PUD 07-000006

PLANNING DEPARTMENT

PLANNED UNIT DEVELOPMENT PERMIT NO. 07-000006 (PUD 07-000006)

TMK: 7-3-054: 010 & 043 (formerly 7-3-005: 012); Kalaoa 4th, North Kona, Hawaii

Exhibit 1: Yard Designation Variance Request - Zoning Code

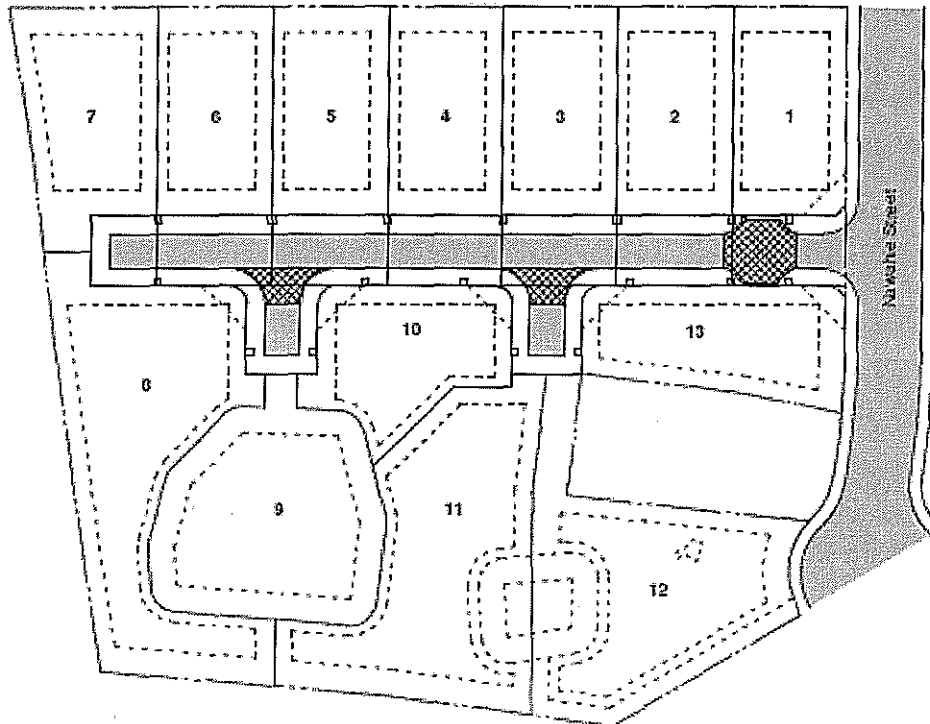
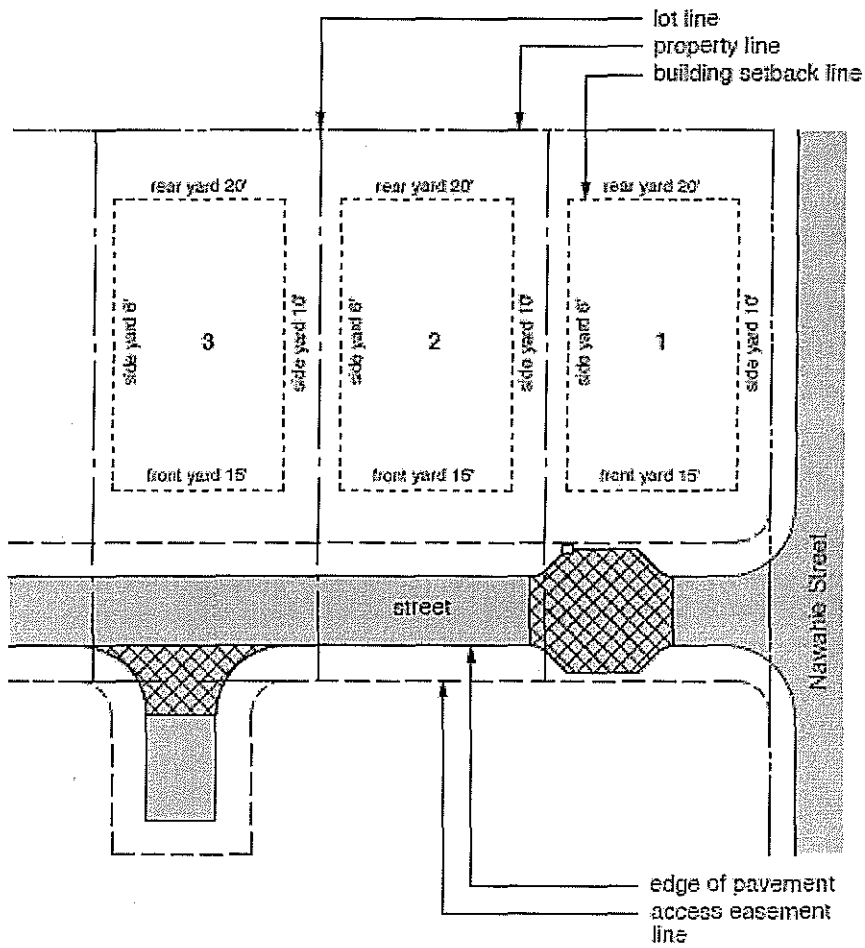
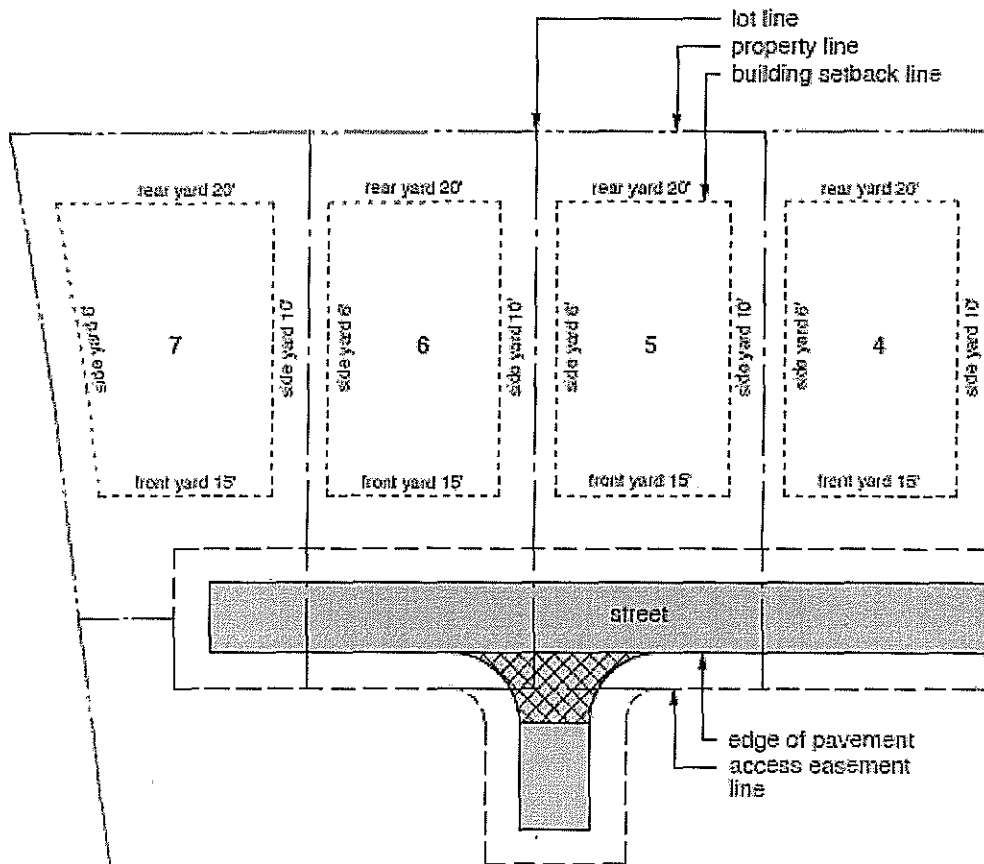
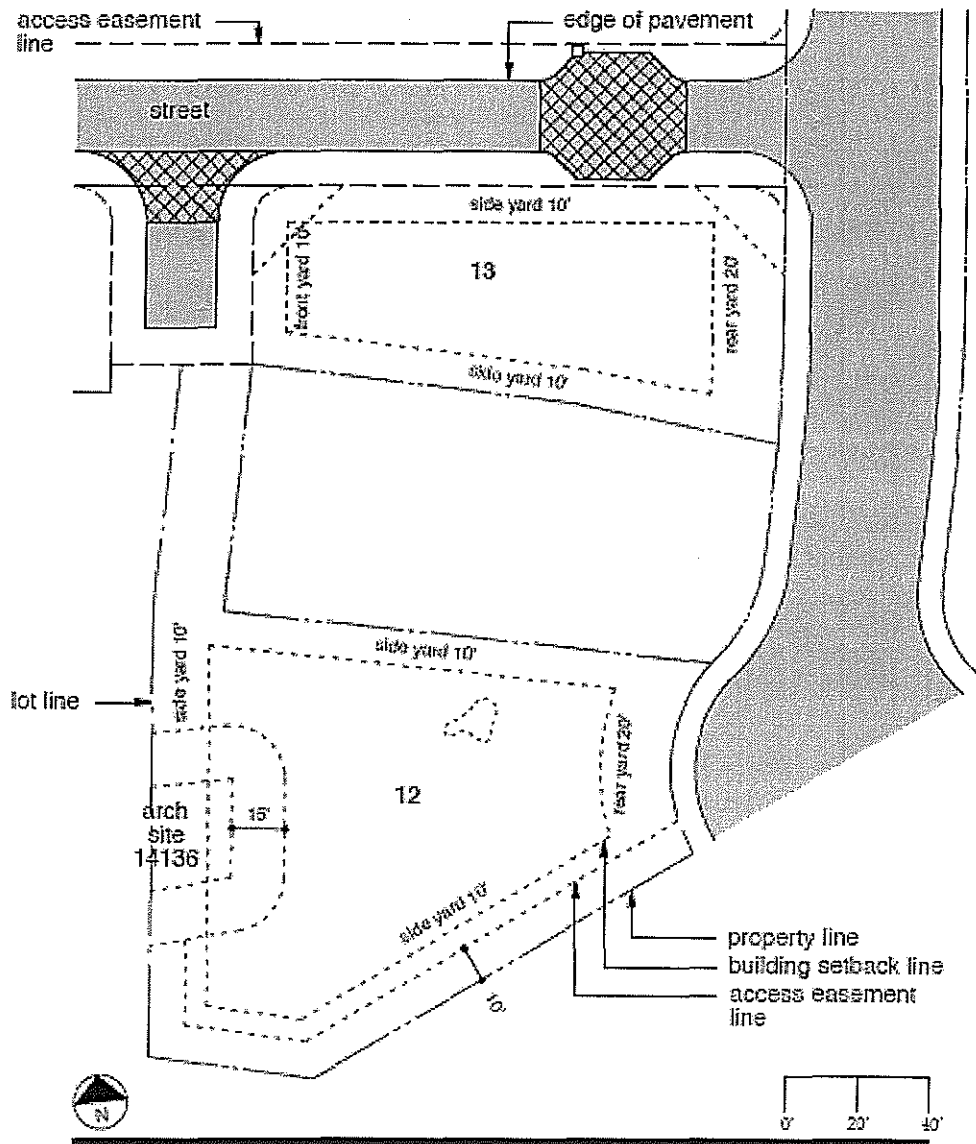
- **General Requirements for Yards and Open Spaces** (Hawaii County Code §25-4-40). Applicant is requesting flexibility in the designation of yards fronting roadways and access easements, as detailed within Exhibits 1 through 5, especially when these lots will have two roadway frontages.

- **Corner Building Sites** (Hawaii County Code §25-4-42). Allow for the designation of front and side property lines for corner lots which do not follow the typical standards for application. We do not have an object to the granting of this variance under the condition that the application of yards and setbacks, as provided by the PUD, is limited to the configurations shown on Exhibits 1 through 5.

- **Minimum Yards** (Hawaii County Code §25-5-76). The minimum yards in the RS-10 zoned district are 20 feet from the front and rear property boundaries and 10 feet from the side property boundaries. Exhibits 1 through 5 reflect the various application of minimum front yards, no less than 15 feet, from either existing road rights-of-way or from the interior subdivision roadway easements. Typically, a minimum front yard setback of 20 feet will be applied to all lots fronting both the subdivision access road and Nawahie Street, consistent with Zoning Code requirements. For lots within the subdivision itself, minimum front yards of 15 feet from the edge of the roadway easement will be applied. Side yards no less than 6 feet will be permitted in lieu of the standard 10-foot wide side yards. However, the side yards will be staggered between a 6-foot setback and a 10-foot setback so that each structure will have at least 16 feet between them. This structural setback is similar to a property that is less than 10,000 square feet in size, which is basically representative of the proposed lots in this PUD application.

Exhibit 6: Fences and Accessory Structures Variance Request - Zoning Code

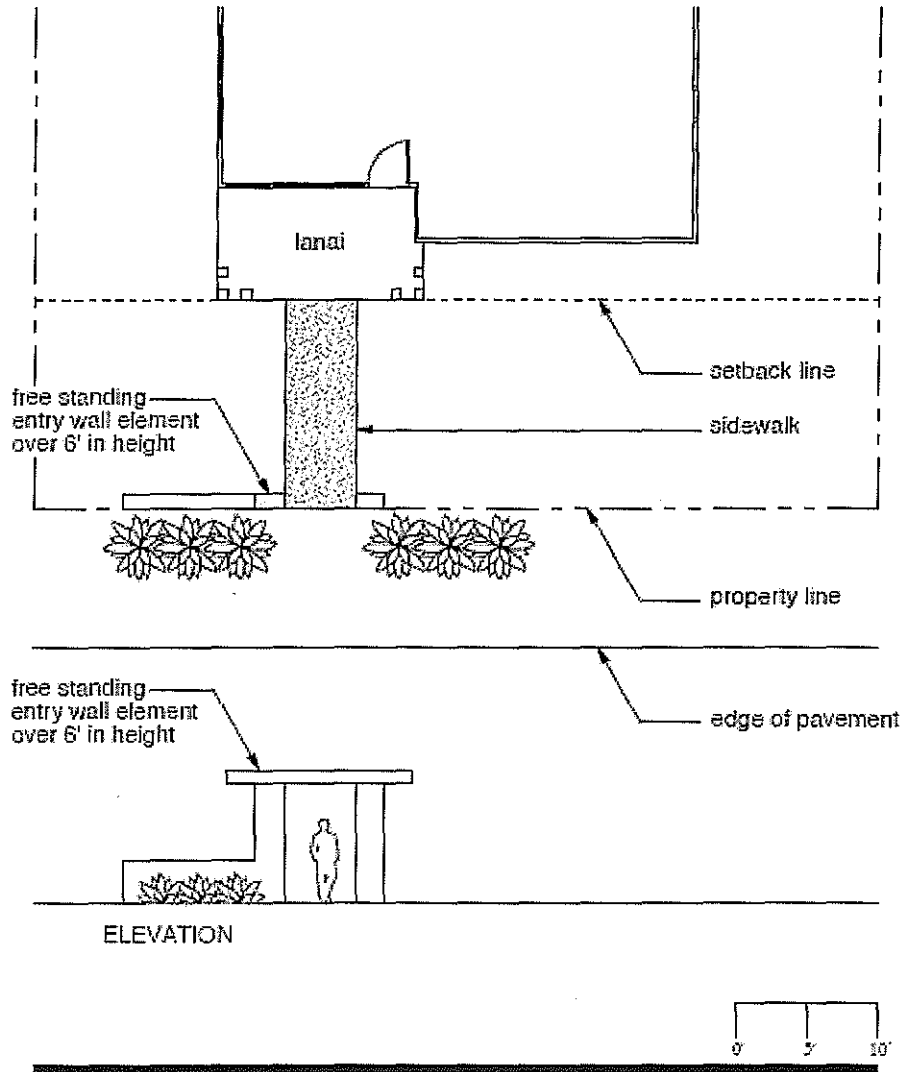
- **Fences and Accessory Structures** (Hawaii County Code §25-4-43). Applicant incorrectly makes reference to retaining walls being limited to 6 feet in height. Maximum height of fences and walls are applied to boundary walls, not retaining walls. The Applicant also wishes to allow for free-standing entry wall features over 6 feet in height into the minimum front yard setback. We have no objection to this requirement, provided it is limited to free-standing entry wall features only as depicted on Exhibit 6 and will not apply to accessory structures, boundary walls or fences.

Exhibit 7: Street Intersection Angles and Radius Variance Request - Subdivision Control Code

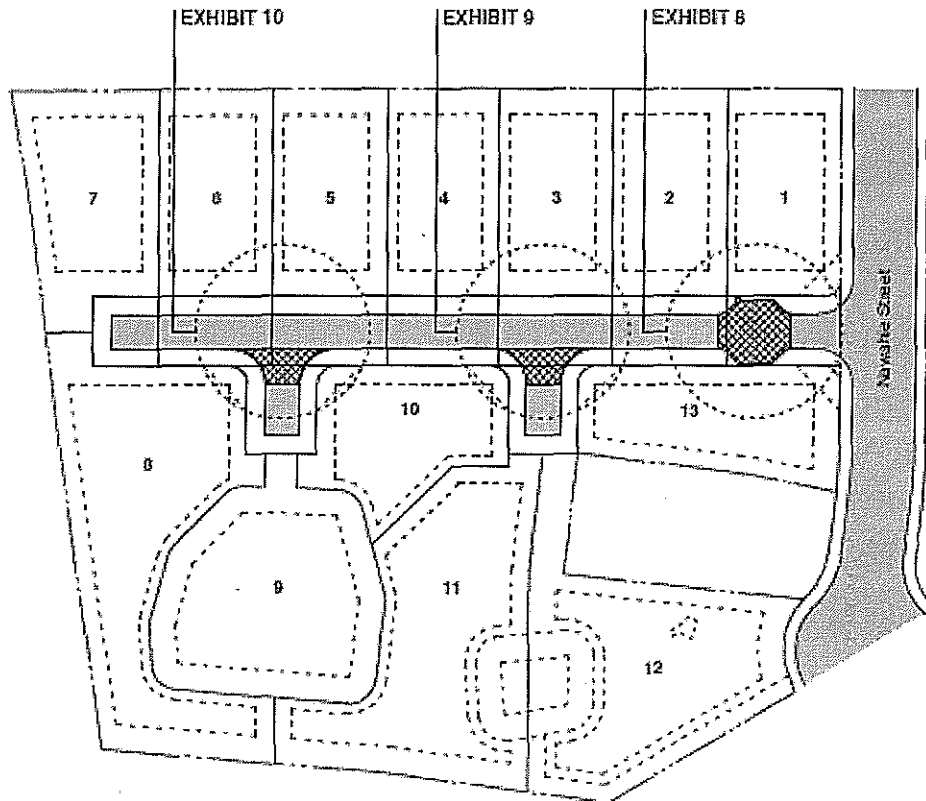
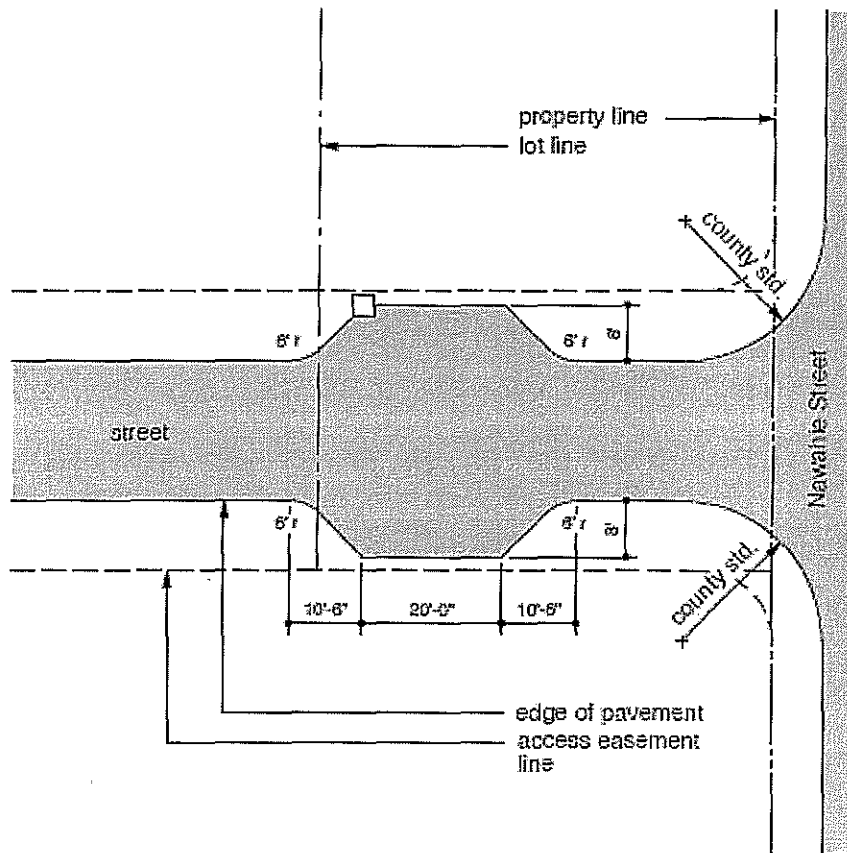
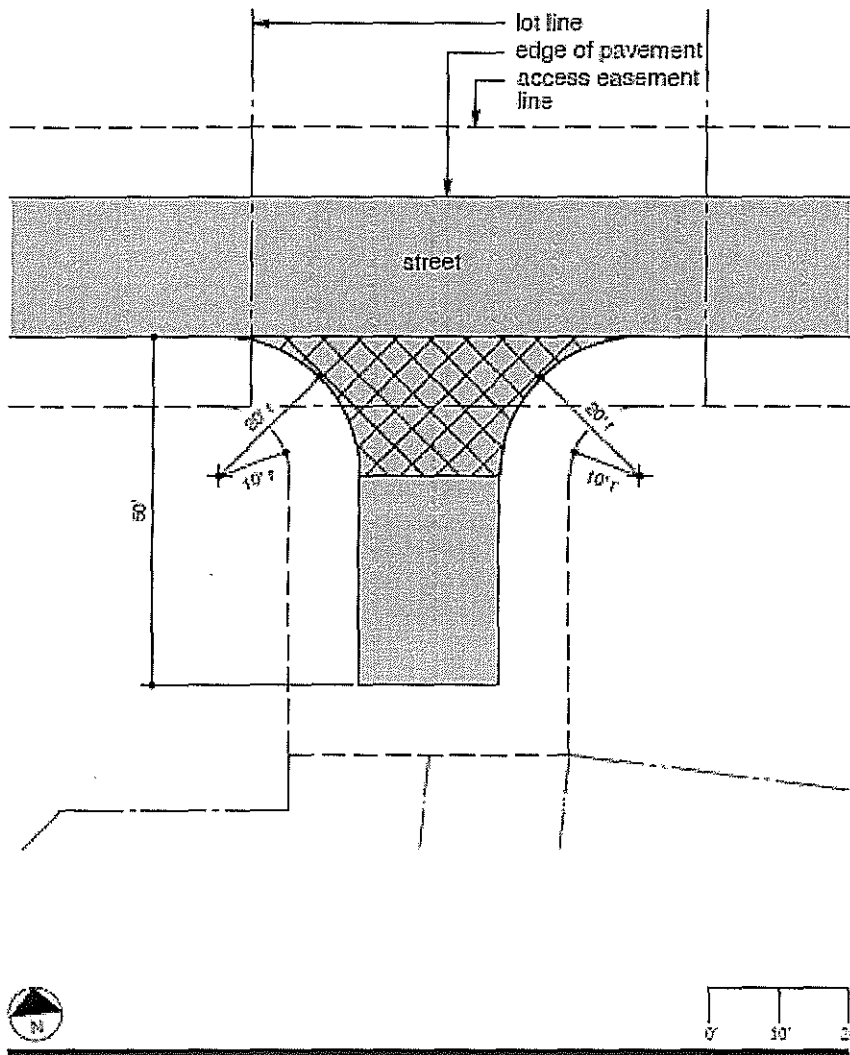
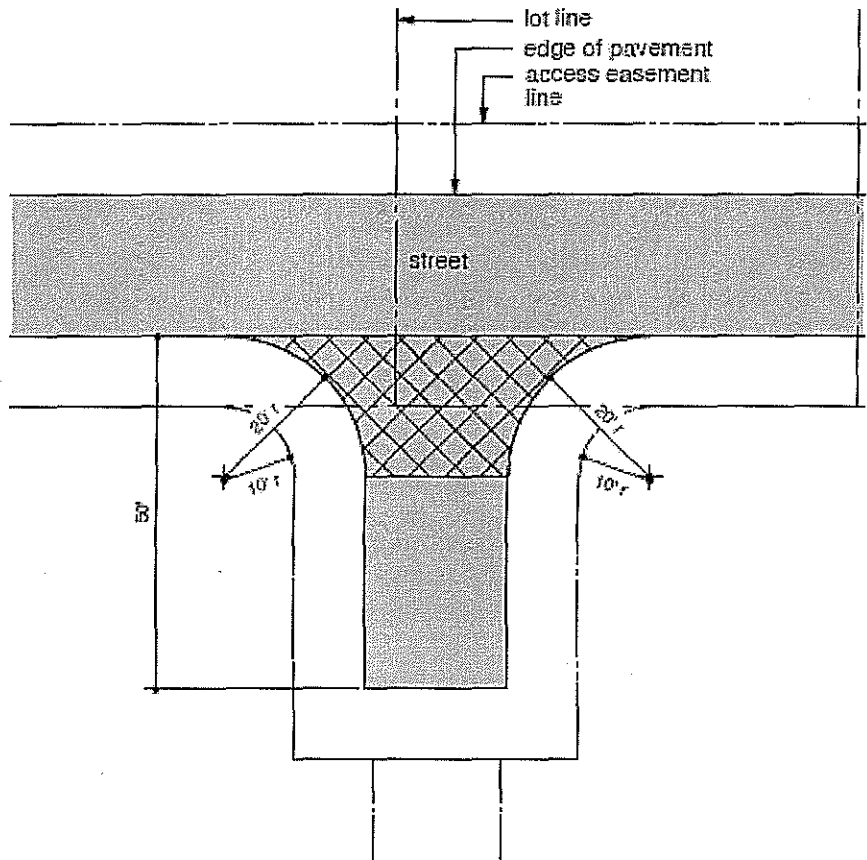
- **Corner radius** (Hawaii County Code §23-45(b)). Applicant requests that intersections within the private roadway easements have a maximum radius of 10 feet, subject to sight distance requirements at the pavement line with the actual pavement having a radius of no less than 20 feet. This variance is approved on the basis that these corner radiuses will occur only at those intersections between the subdivision access road and the common access driveways. Since these intersections are essentially driveways, anticipate limited traffic volumes and speeds, thereby warranting this particular variance. The reduced corner radius combined with traffic calming measures result in safer pedestrian environment.

The intersections of the subdivision access road and Nawahie Street should have a compliant corner radius to accommodate larger vehicles, such as buses. According to the Department of Public Works, the construction plans submitted to date show a Standard Detail R-29 drop driveway at that approach. The Department of Public Works has no objection to an R-29 driveway approach in combination with no property line return radius at Nawahie Street if made a specific or alternate condition of this PUD. Such a condition will be provided.

4. Preliminary construction drawings for the proposed subdivision access road show a Standard Detail R-29 drop driveway at its Nawahie Street approach. The Department of Public Works has no objection to an R-29 driveway approach in combination with no property line return radius at Nawahie Street. The Applicant shall comply with this recommendation.

Exhibit 12: Street Signs

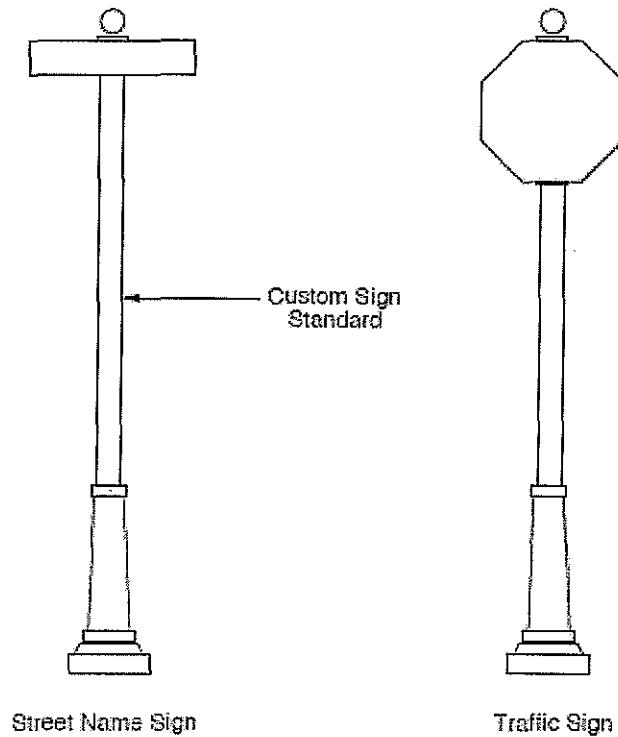
- **Street names & traffic signs** (Hawaii County Code §23-94). Approved to allow use of custom street name and traffic signs that will reinforce the desired character of the neighborhood and its design goals (see Exhibit No 12). While this variance will allow these signs to deviate from standard specifications, it must still meet ASHTO specifications.

Exhibit 13: Right of Way Improvement Variance Request - Subdivision Control Code

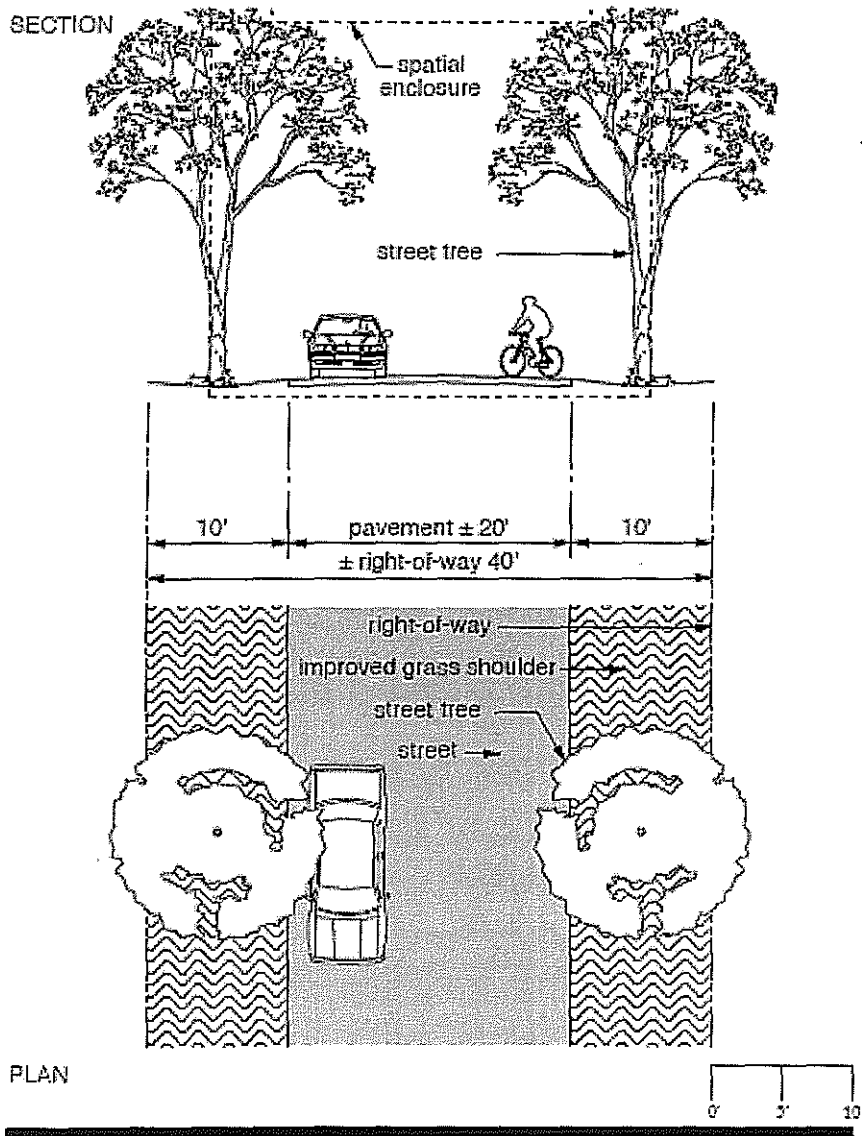
The proposed subdivision roadways include a minimum 40-foot wide access easement having a pavement width of 20 feet with 10-foot wide grassed shoulders with street trees, in lieu of the minimum 20-foot wide pavement within a 50-foot wide right-of-way required by the Subdivision Code (Exhibit 13) and specified by Department of Public Works Standard Detail R-33.

Section 23-41. – A specific right of way and pavement width should be required for clarity of plat and plan review. We have no objection to 20 feet of pavement centered in a 40-foot right-of-way.

- **Minor Street (40' wide roadway easement in lieu of 50' ROW-Exhibit 13)**. The proposed standards for the 40-foot wide minor street-type roadway easement will deviate from the minimum 50-foot wide ROW specified by DPW Standard Detail R-39. The Applicant is proposing a pavement width of 20 feet with 10-foot wide grassed shoulders on each side. The lower volume and speed of vehicles typically carried by these minor streets affords the opportunity to reduce the pavement width and manage speeds. The proposed 20-foot wide pavement, which does meet County standards, will provide opportunities for a landscaped shoulder/drainage swale while still accommodating two-way vehicular traffic.

- **Right of way Improvement** (Hawaii County Code §23-95). There is no justification for this variance. Plans submitted by the Applicant indicate that the entire roadway easement will be improved with either a paved travelway or graded and grassed shoulders. These improvements, as permitted by this PUD, satisfies this particular requirement.
